Correspondence Between Staff and Applicant

**RE: 4-GP-2019 & 14-ZN-2019
Seventh Day Adventist Rezoning**

Case Review – Seventh Day Adventist Rezoning

PROJECT NAME: SEVENTH DAY ADVENTIST REZONING
LOCATION: NWC OF SCOTTSDALE ROAD AND SUTTON DRIVE
CASE NUMBER: 14-ZN-2019

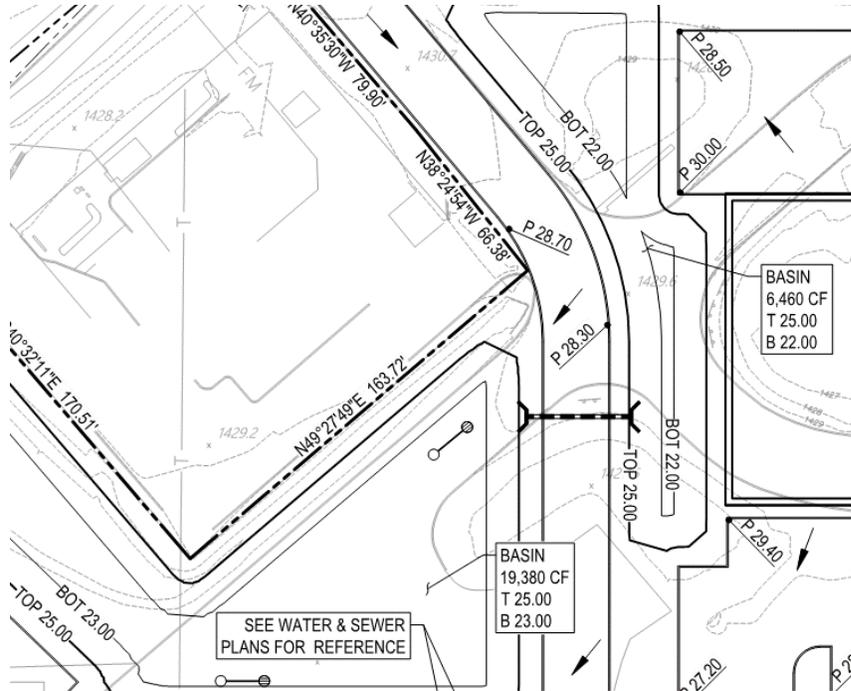
1. 1st Review: The Preliminary Drainage Report states that “no offsite flows appear to impact the Site.” Based on available existing topo, it appears that the northeast corner of the site is impacted by offsite flow. Address this in the drainage report.

2nd Review: This comment has only been partially addressed. The report has been revised to acknowledge offsite flow, however this offsite flow is neither quantified or addressed in the conceptual drainage design. This will need to be addressed as a stipulation to provide detailed analysis. (AOM 12/23/2019)

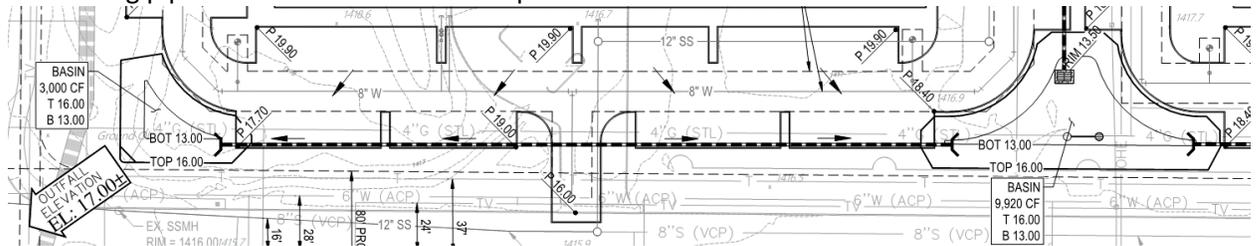
4. Some proposed stormwater basins do not have a means to drain by gravity. For example, as shown below, the basin with a bottom elevation of 23.0 has a proposed drywell; however, the basin with a lower bottom of 22.0 has no means to drain.

In the following example, the basin to the west is intended to be equalized with the basin to the east, which is to drain via drywell. However, in order to drain properly and avoid standing water, the basin to the west should have a bottom that is almost two feet higher so that the approximately 360-ft long connecting pipe will have the minimum slope of 0.5% to drain.

2nd Review: This comment has not been addressed. This will need to be addressed as a stipulation. (AOM 12/23/2019)
